Seismic Walkdown Checklist (SWC)

Equipment ID No. 1-1205-EG-002 Equip. Class¹² 21 (Tanks and Heat Exchangers)
 Equipment Description RHR HEAT EXCHANGER B
 Location: Bldg. AUX Floor El. 143'-6" Room, Area RC-91
 Manufacturer, Model, Etc. (optional but recommended) _____

Equipment ID No. 1-1302-14-003 Equip. Class¹² 5

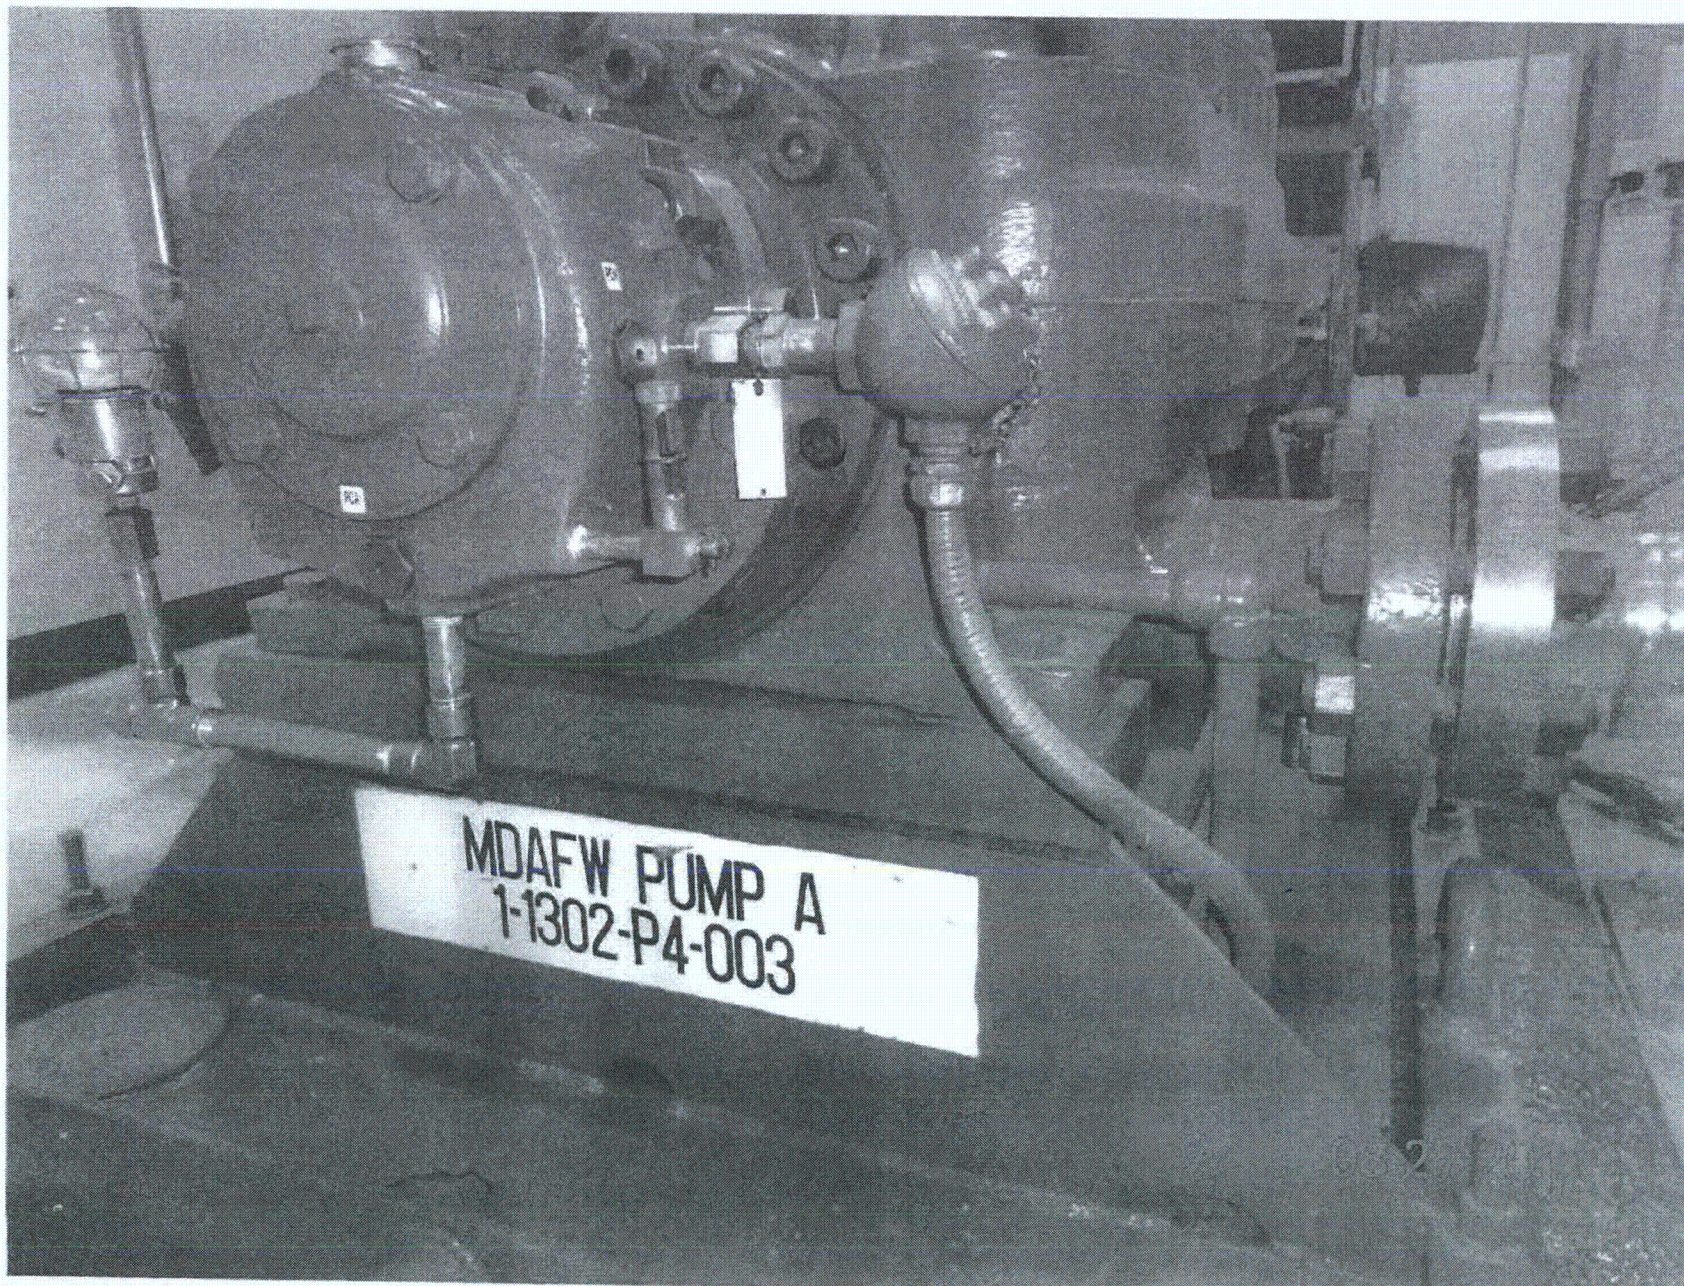
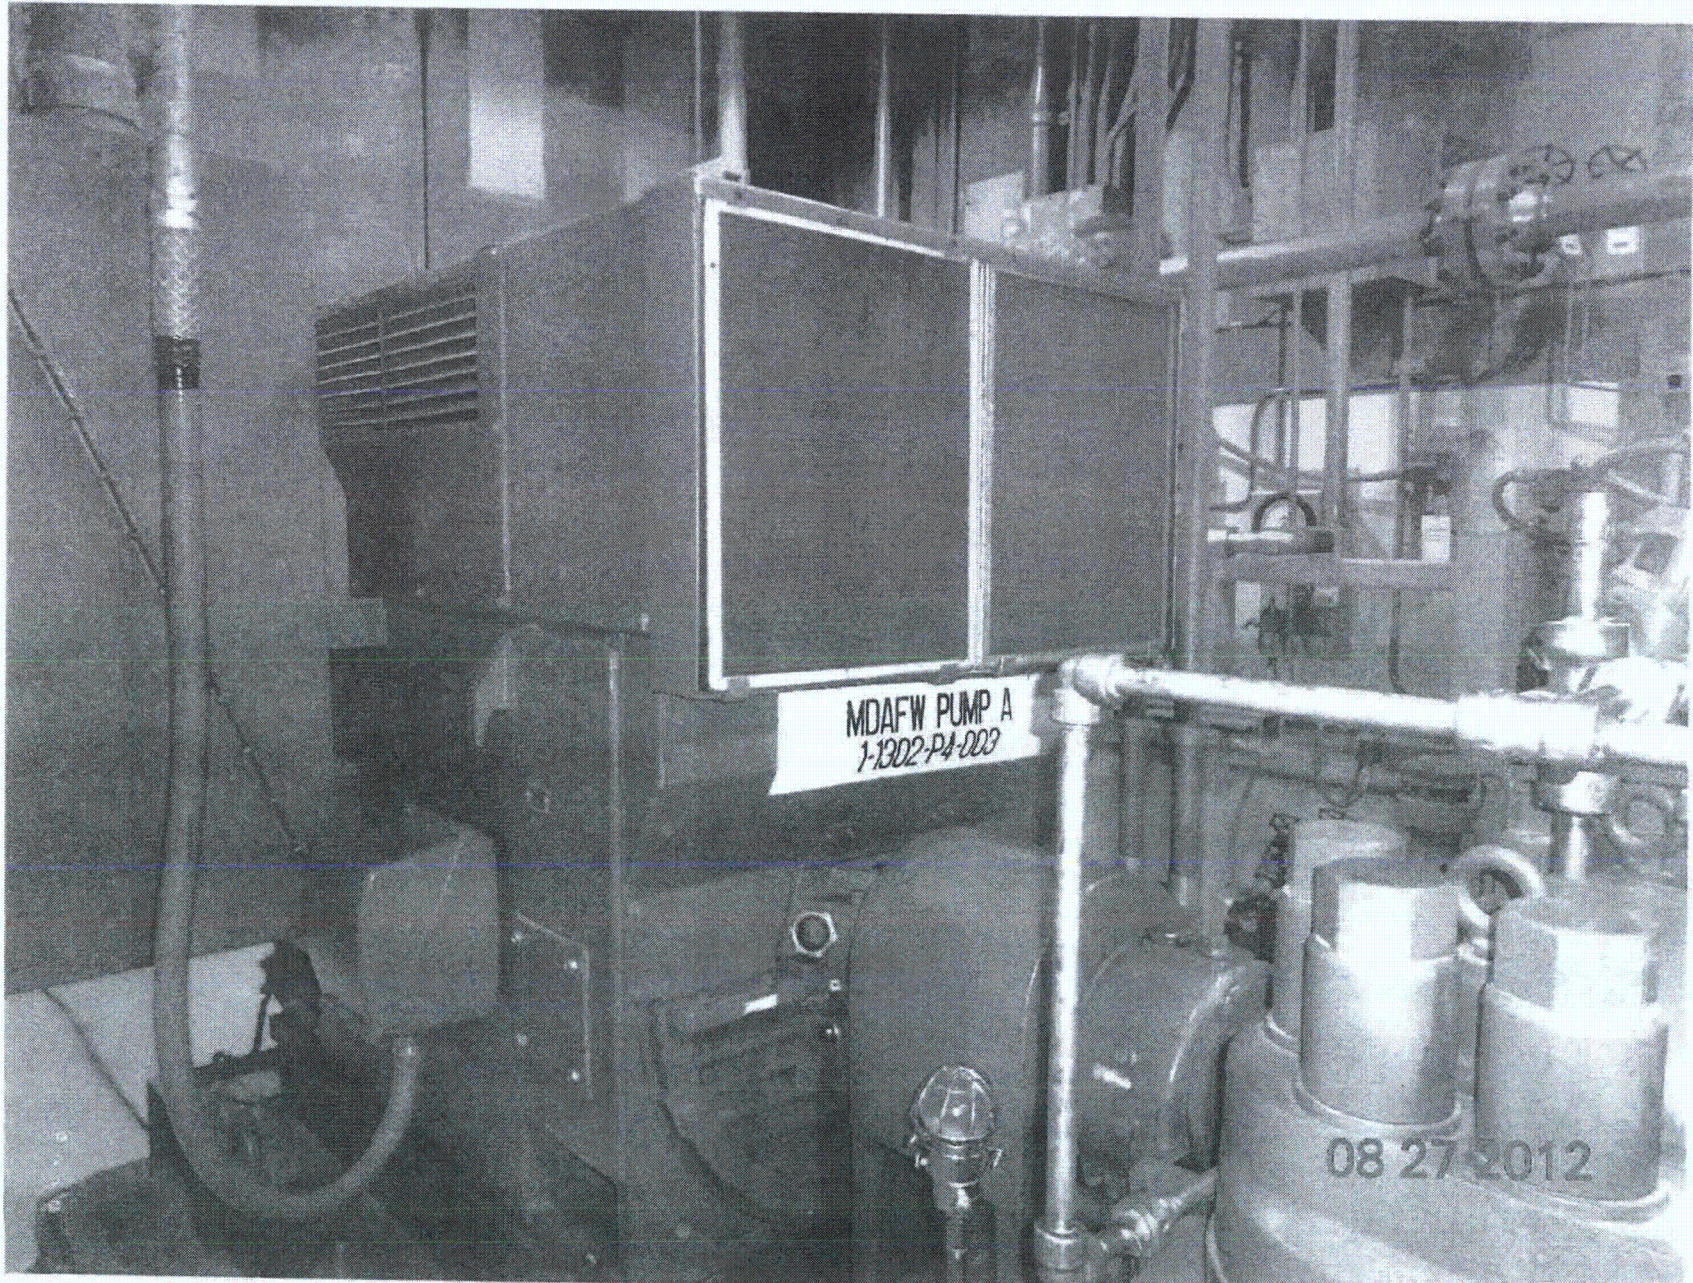
Chain basket for mono rail has enough clearance OK
Scaffold SWC 394025 is temporary erected OK
